1989 Porsche 911 Carrera 4 Coupe AWD F6-3600cc 3.6L SOHC

Seat Rail - Adjusting For More Leg Room

9301

Adjusting seat rails for more leg room.

Figure 1

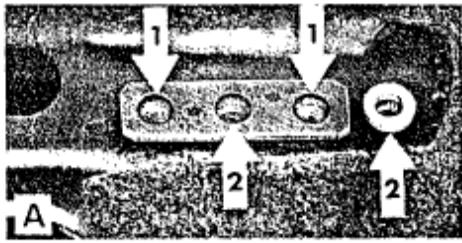
The seat rails for the above mentioned vehicles can be repositioned to allow for more leg room. The distance the seat is moved compared to the factory setting is 22.5 mm for 911 Carrera 2/4/Turbo and 25 mm for 928 models.

1. Move the seat to its rear most position and remove the two front allen head bolts which secure the seat rails.
2. Move the seat to its forward most position and remove the four rear allen head bolts which secure the seat rails.
3. On vehicles with electric seats, disconnect the wiring harness to the seat.
4. Lift and remove the seat from the vehicle on 911 Carrera 2/4/Turbo models.
5. 911 Carrera 2/4/Turbo - On the inside/rear securing point, place a 3mm thick washer, Part Number 999 025 125 09, on top of the rear thread bore opening (Figure 1). It may be necessary to cut the carpet to access this area.

Arrow 1: Production securing points
Arrow 2: Modified securing points

Figure 2

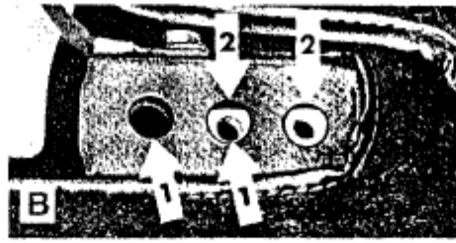
6. 911 Carrera 2/4/Turbo - On the outside rear securing point, slide the threaded plate to the rear bore opening (Figure 2). Reinstall and secure the seat.
7. 928 Models - Slide the seat to the rear mounting points and secure the seat (Figure C).
